UNITED STATES  
NUCLEAR REGULATORY COMMISSION  
WASHINGTON, D. C. 20566

The Commission has issued the enclosed Amendments Nos. 87, 87, and 84 for Licenses Nos. DPR-38, DPR-47 and DPR-55 for the Oconee Nuclear Station, Units Nos. 1, 2 and 3. These amendments consist of changes to the Station's common Technical Specifications and are in response to your submittal dated July 22, 1980.

These amendments revise the Technical Specifications for Oconee Units 2 and 3 by modifying the reactor vessel pressure-temperature operating limit curves to enable the extension of reactor vessel operation from 4 to 5 effective full power years.

ATTACHMENT TO LICENSE AMENDMENTS

Figure 3.1.2-1B

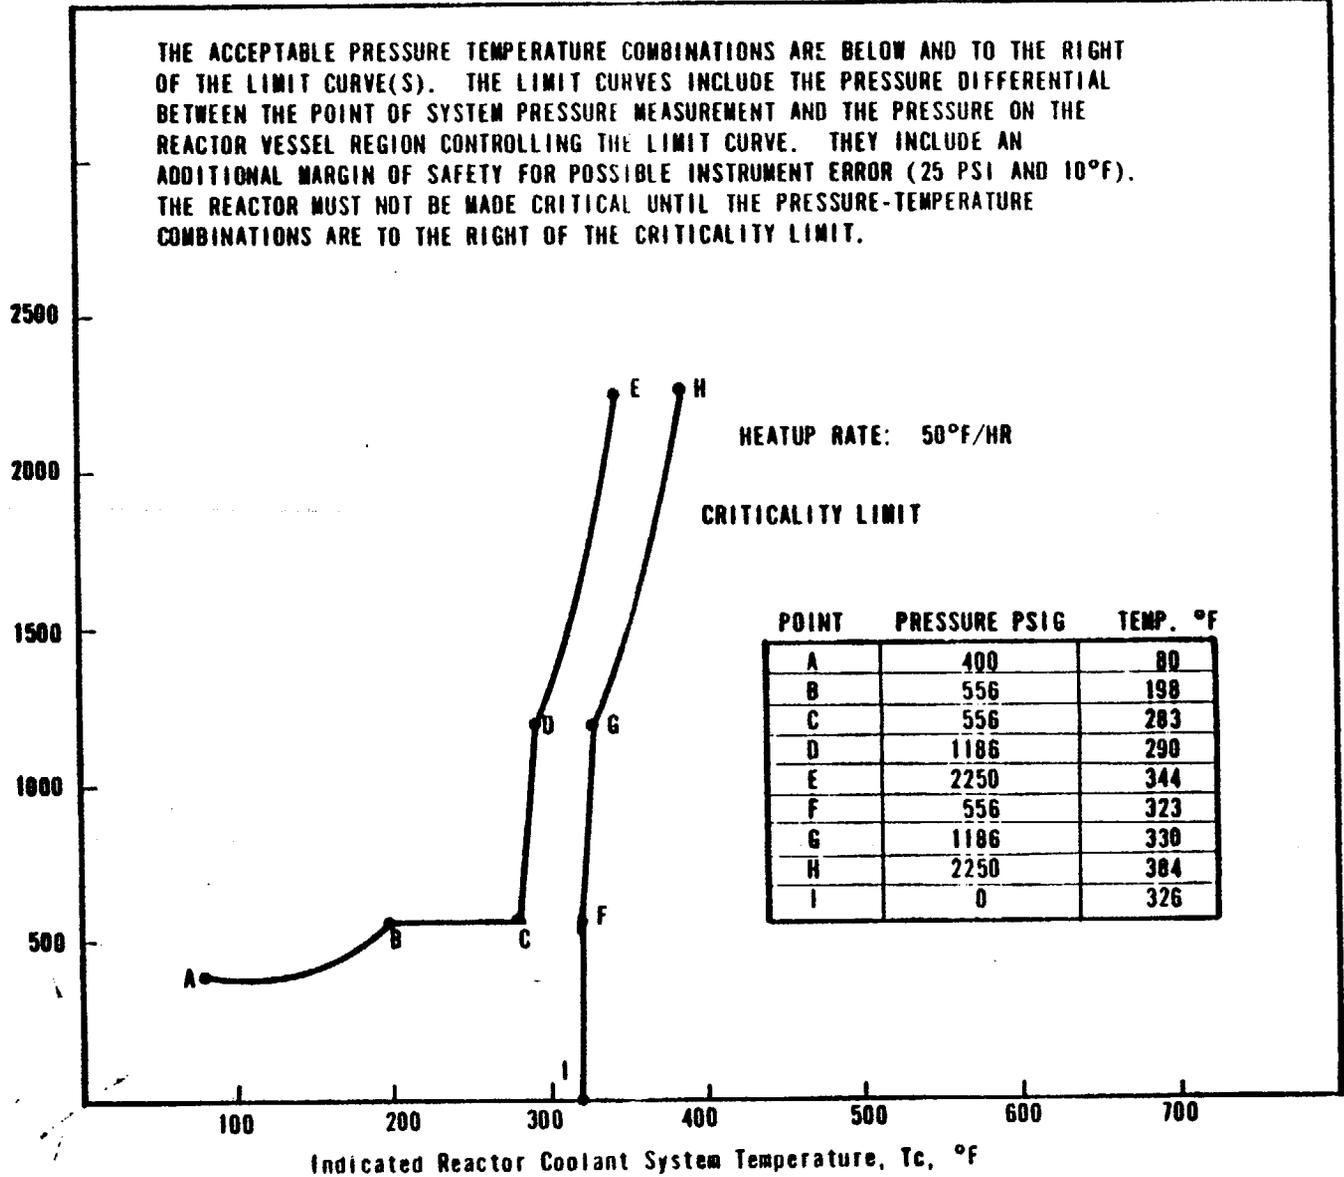
UNIT 2  
REACTOR COOLANT SYSTEM  
NORMAL OPERATION HEATUP LIMITATIONS  
APPLICABLE FOR FIRST 5.0 EFY  
OCONEE NUCLEAR STATION

The licensee has proposed that the current pressure-temperature limits for Units 1 and 2 be revised by increasing the allowable temperatures by 15° F to account for an increase in fluence corresponding to one EFPY. This would make the revised curves applicable for 5 EFPY instead of 4 EFPY.

Figure 3.1.2-28

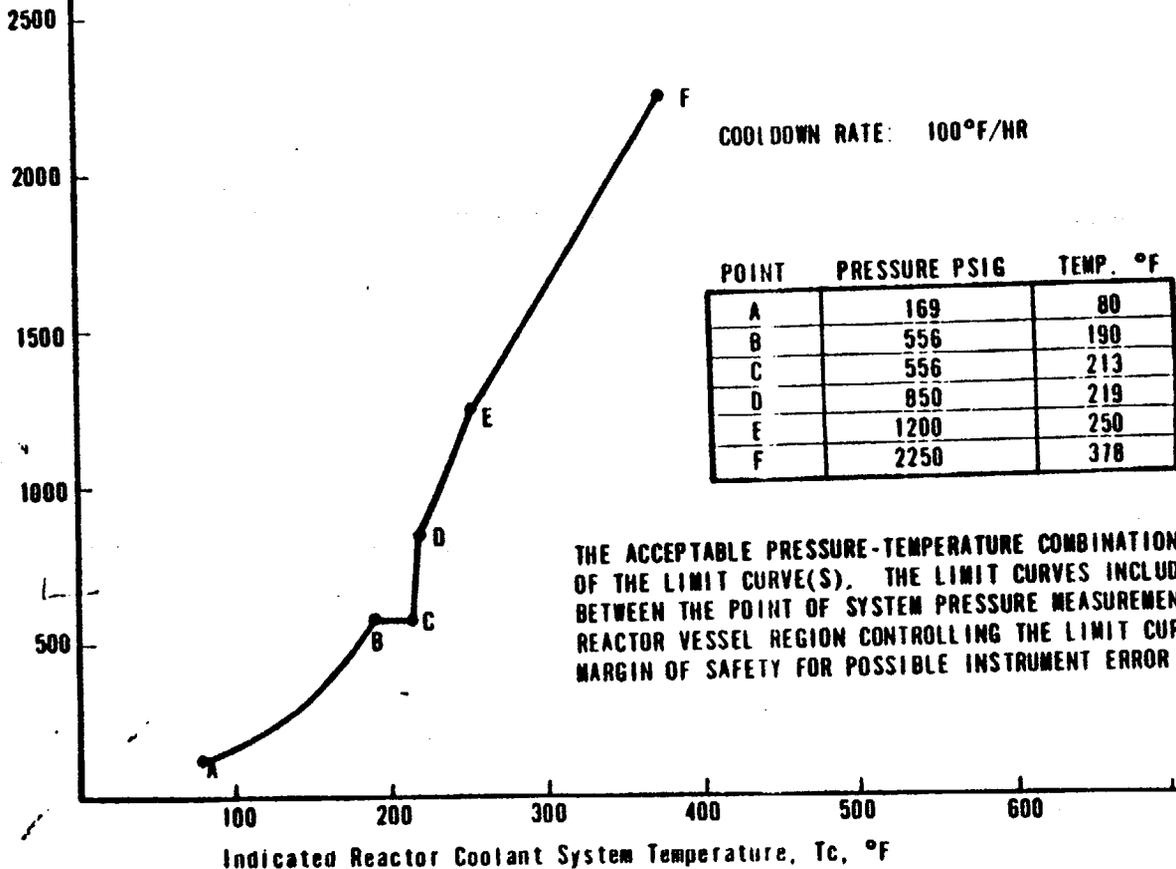
UNIT 2  
REACTOR COOLANT SYSTEM  
NORMAL OPERATION COOLDOWN LIMITATIONS  
APPLICABLE FOR FIRST 5.0 EFPY  
OCONEE NUCLEAR STATION

Figure 3.1.2-2C

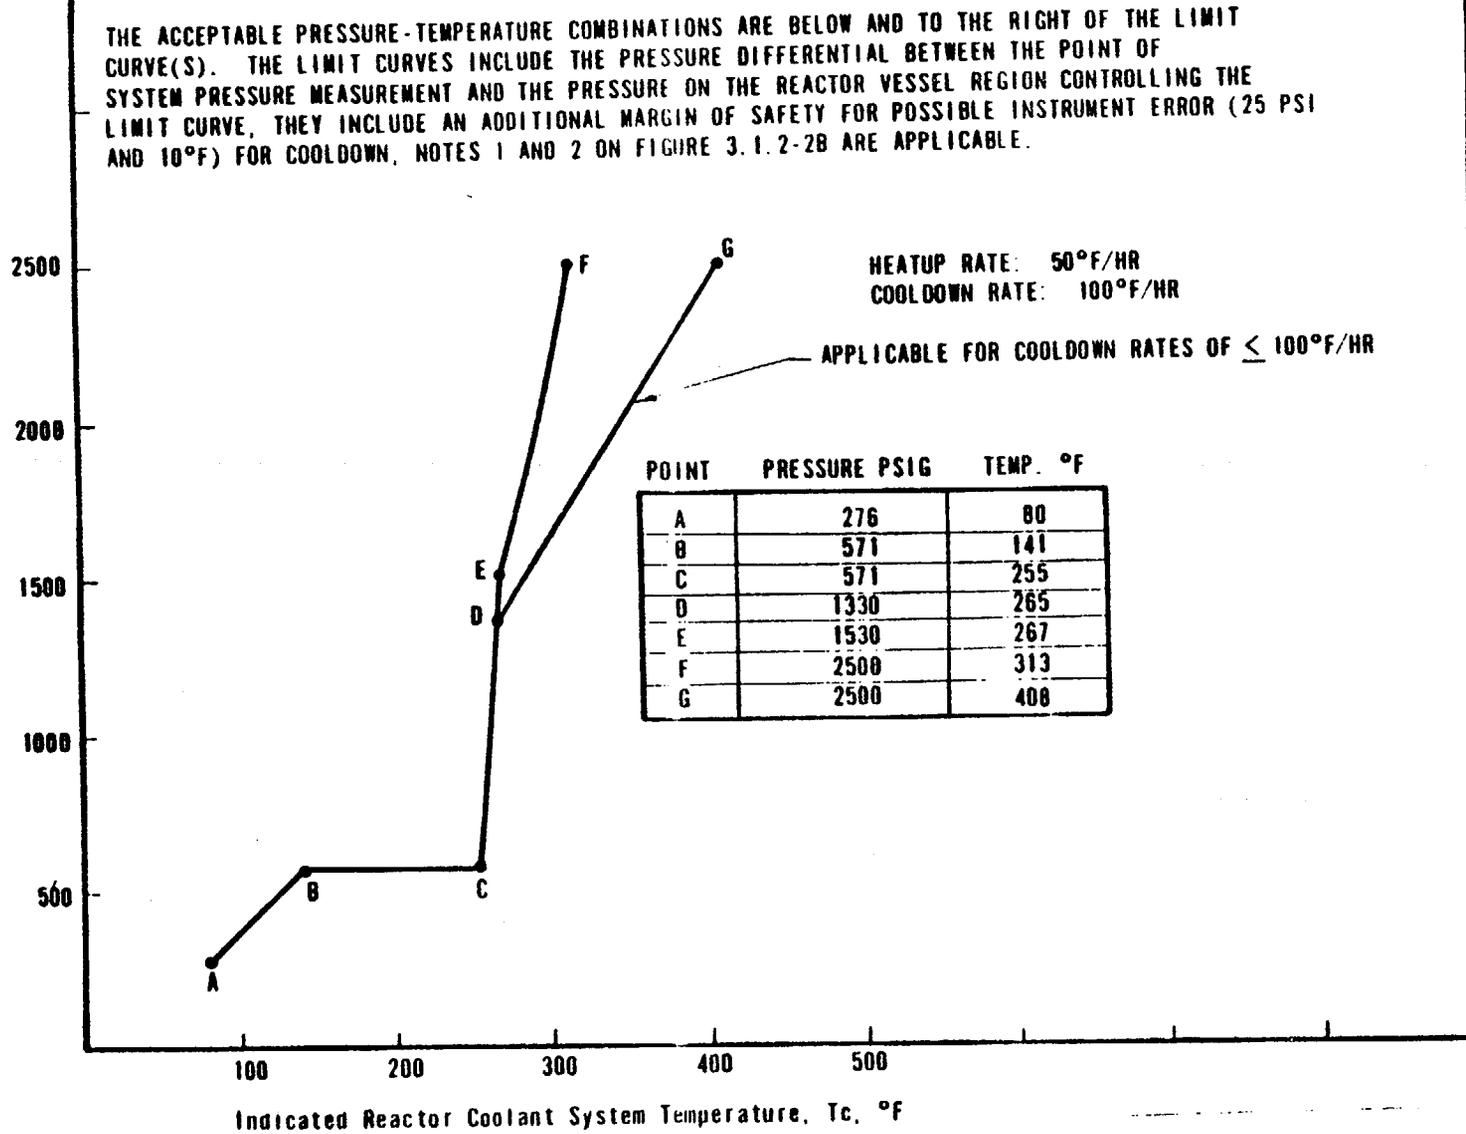
UNIT 3  
 REACTOR COOLANT SYSTEM  
 NORMAL OPERATION COOLDOWN LIMITATIONS  
 APPLICABLE FOR FIRST 5.0 EFY  
 OCONEE NUCLEAR STATION

Figure 3.1.2-3B

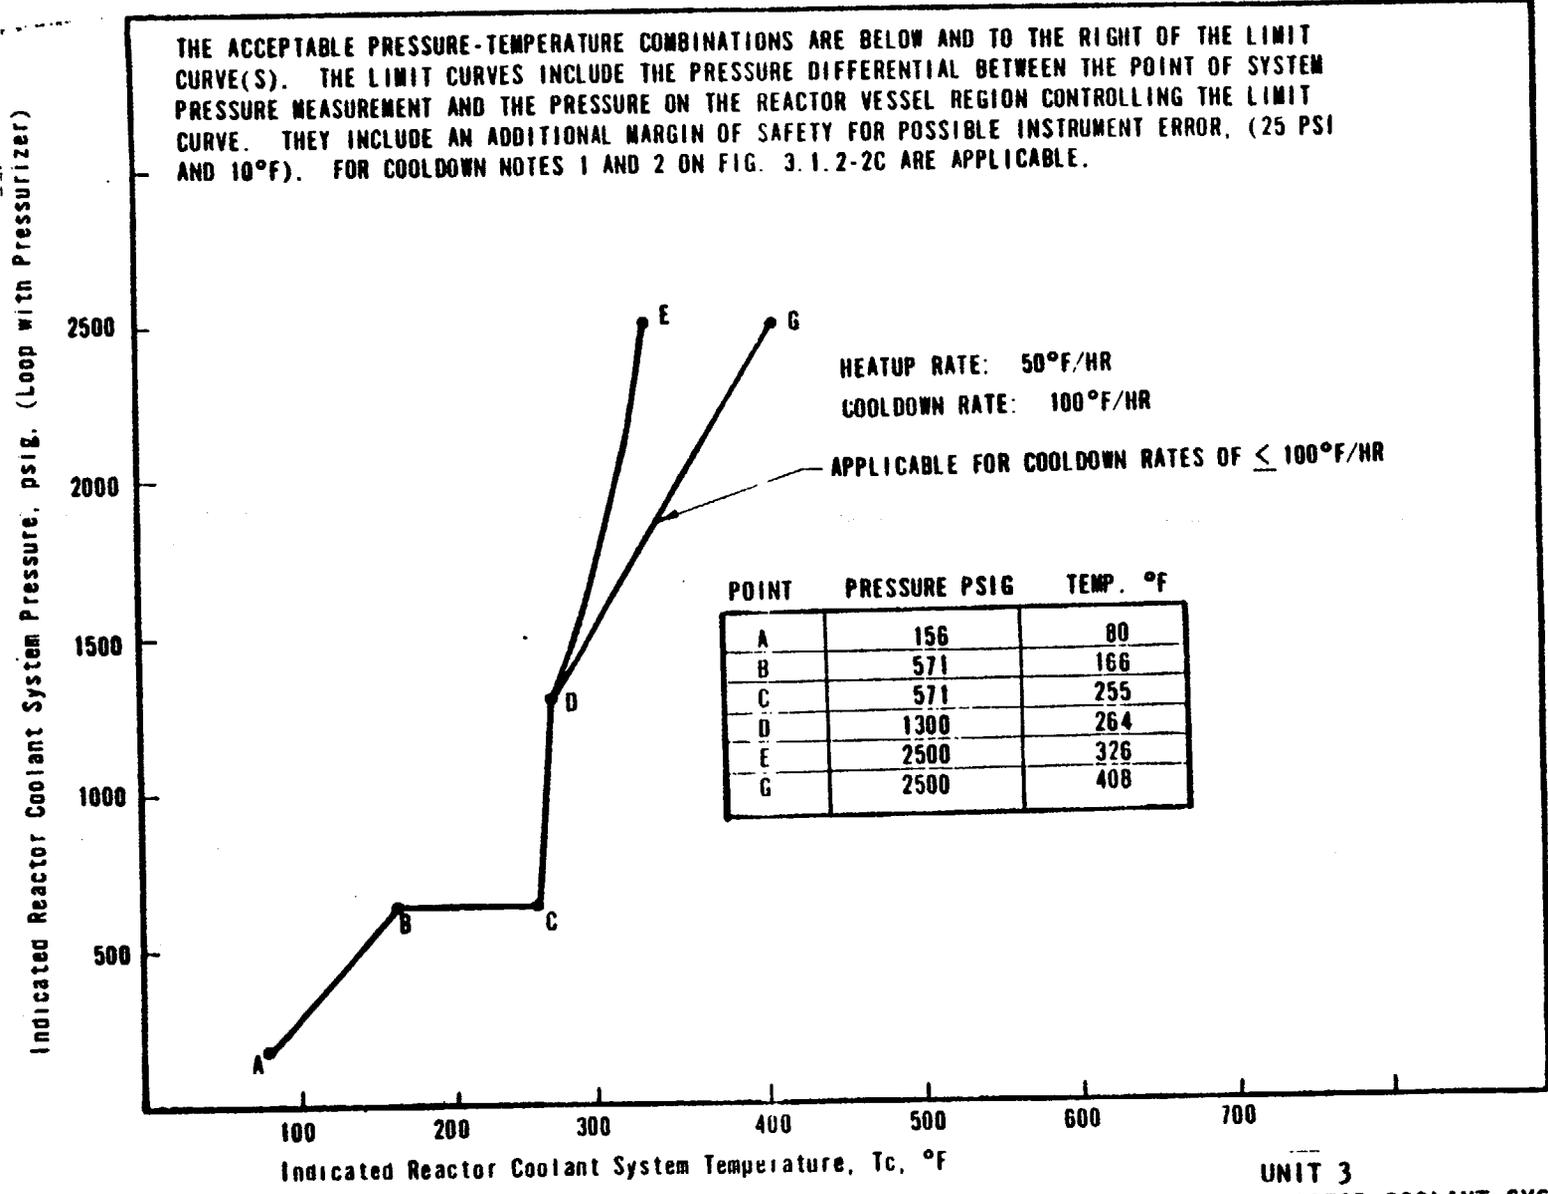
UNIT 2  
REACTOR COOLANT SYSTEM  
INSERVICE LEAK AND HYDROSTATIC TEST  
HEATUP AND COOLDOWN LIMITATIONS  
APPLICABLE FOR 5.0 EPFY  
OCONEE NUCLEAR STATION
